Subject: Responses to NRC Comments on Northeast Ohio Regional Sewer District
Responses dated February 24, 1994 - Site Characterization Plan

RESPONSES TO NRC COMMENTS ON NEORSD RESPONSES
DATED FEBRUARY 24, 1994

Northeast Ohio Regional Sewer District
Southerly Plant - Site Characterization Plan

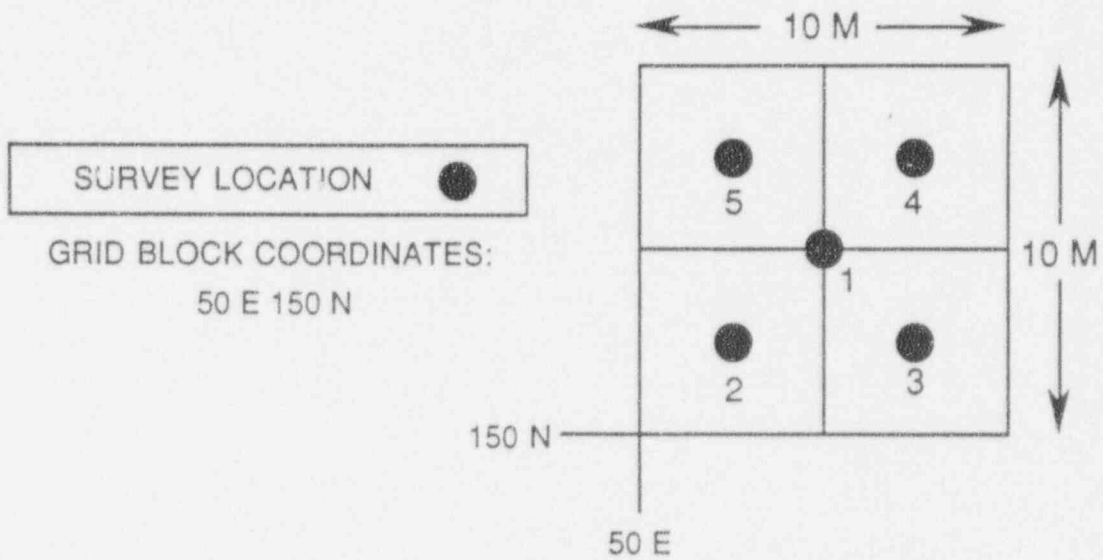
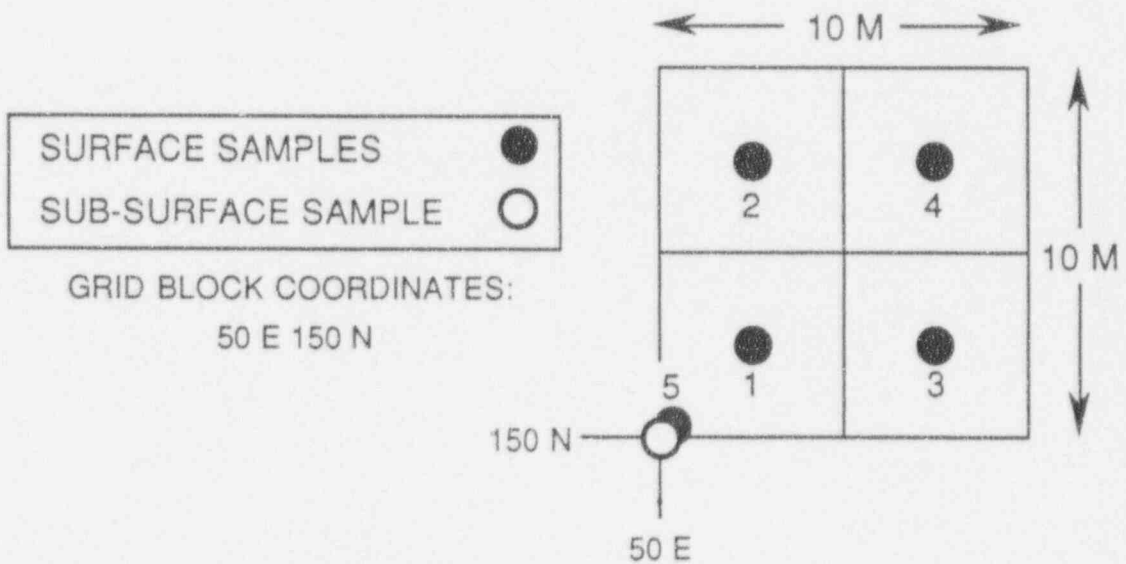
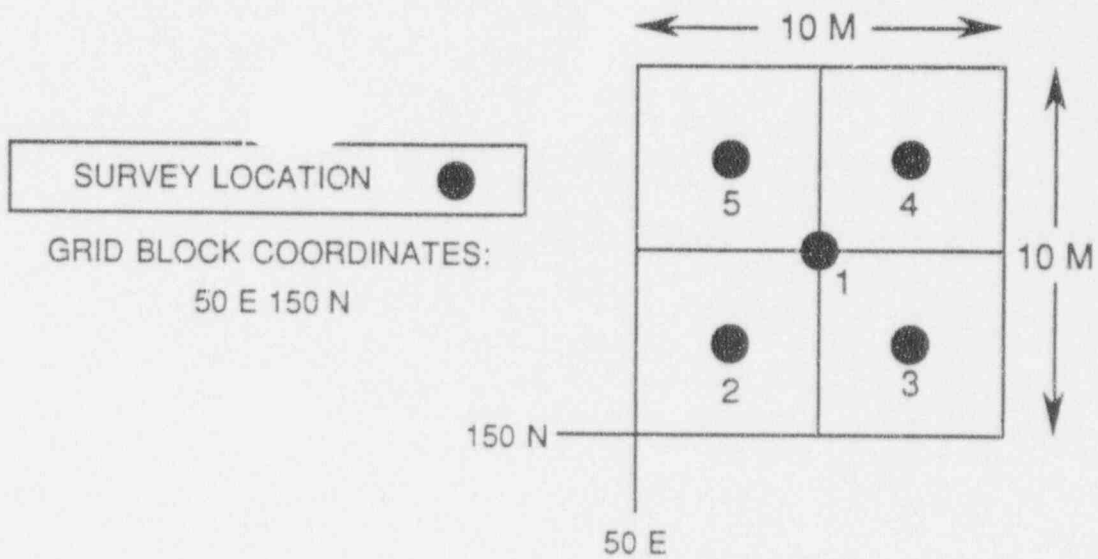
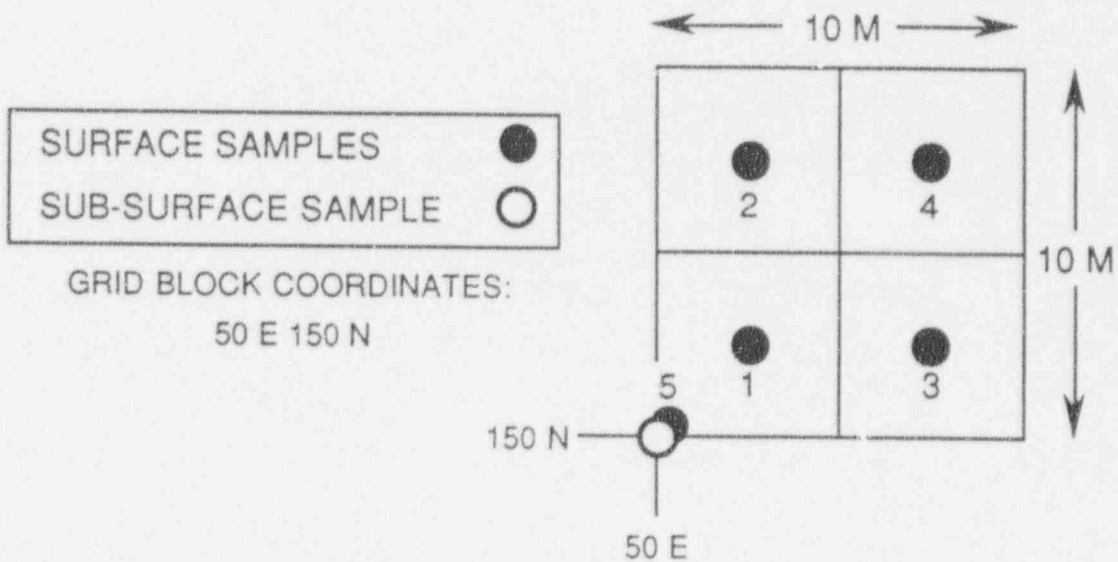
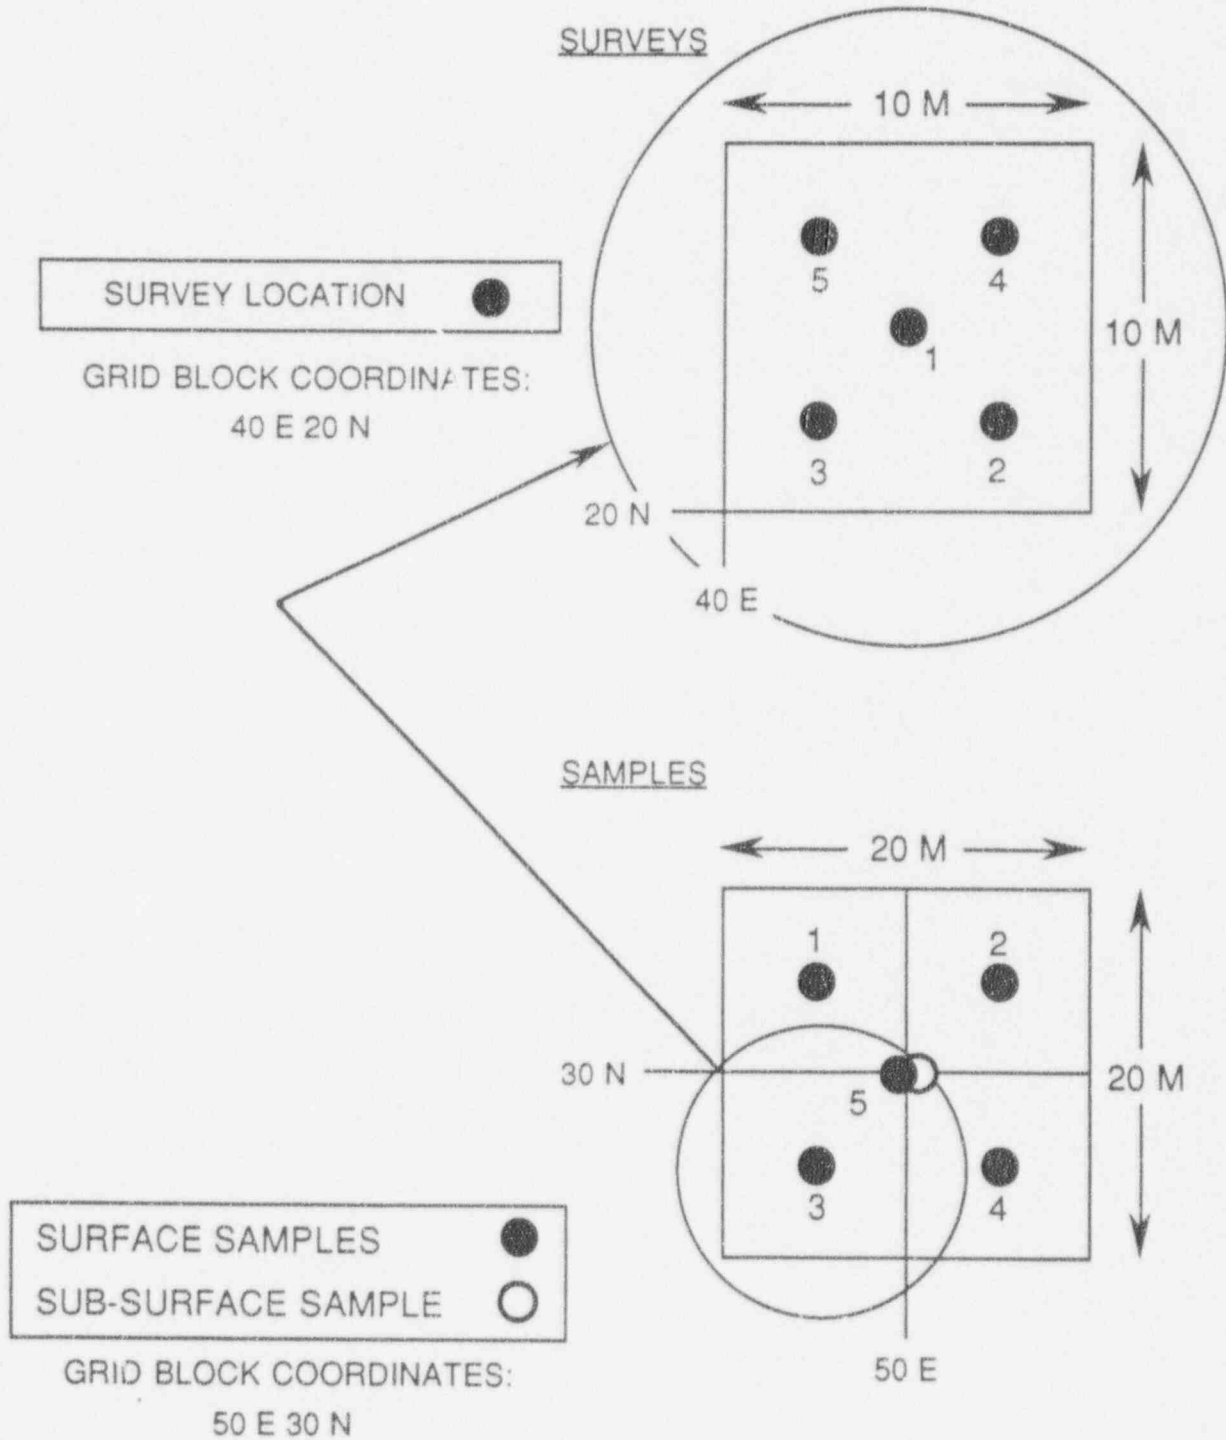
- b. It is not convincing that monitoring wells are not needed around Lagoons A, B, and C. Please provide results of samples collected in clay liner indicating that there was no evidence of Co-60 migration.

As part of the Final Radiological Survey effort, one foot subsurface samples were obtained using a split spoon sampler from the clay liners of the three Lagoons (A, B, and C). The first 6 inches of clay liner samples was considered a surface sample. The last 6 inches of the clay liner sample was considered subsurface. Data from Tables C-2 through C-7 (Attachment 2) from the Final Radiological Survey Report, March 1994 demonstrate that Co-60 has not migrated into or through the clay liner and surrounding areas. Therefore, monitoring wells are not needed around Lagoons A, B, and C.
